Product : LCD Monitor

Bulletin No. : 02-C/M-E0094

Model : GD15*/GD17*

SUBJECT : EEPROM deleted when monitor turn off,on without signal

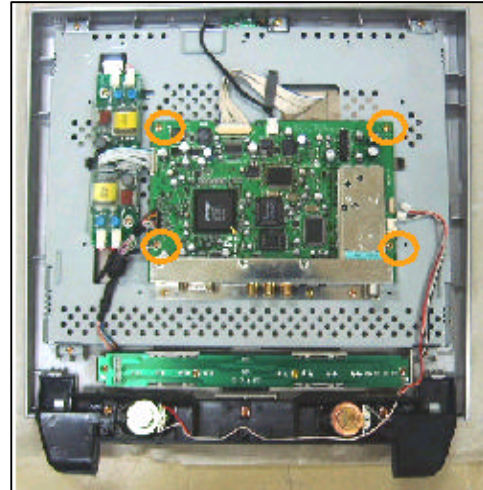
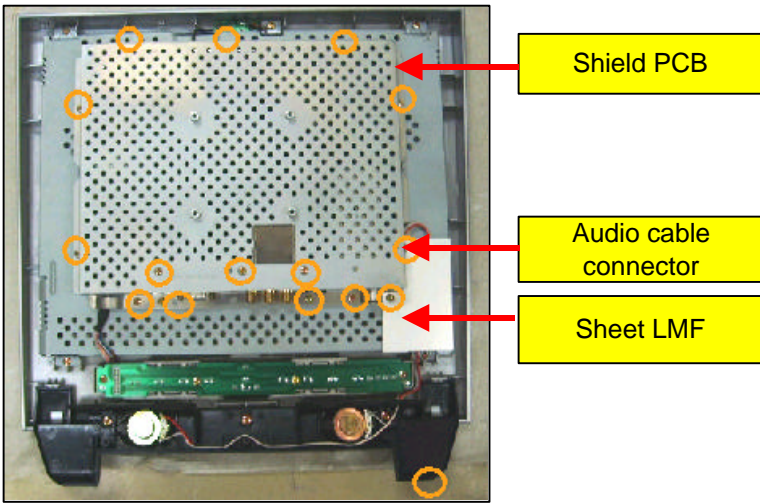
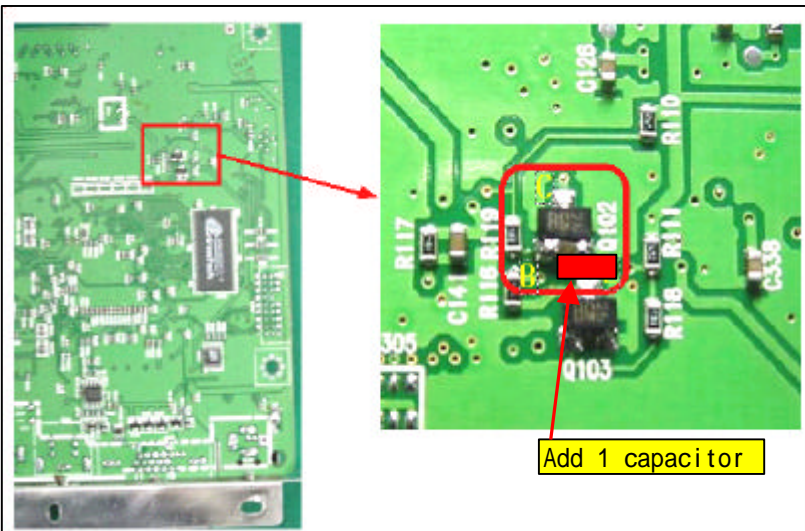
Remove Audio cable

Remove screws (15 pcs) and shield PCB

Remove 4 screws of main board and

remove inverter,function,LVDS,IR cables

Add 1 capacitor on the bottom side of main board

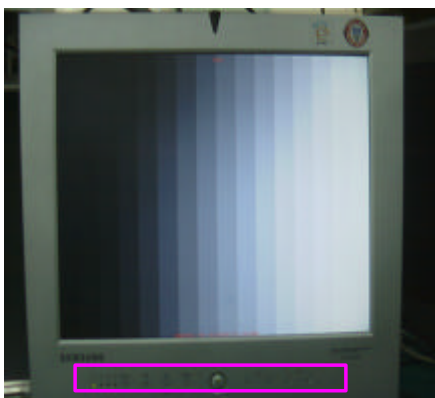
Bottom side of main board
 Add 1 uF capacitor between B and E of Q102
Be careful not to short B and E
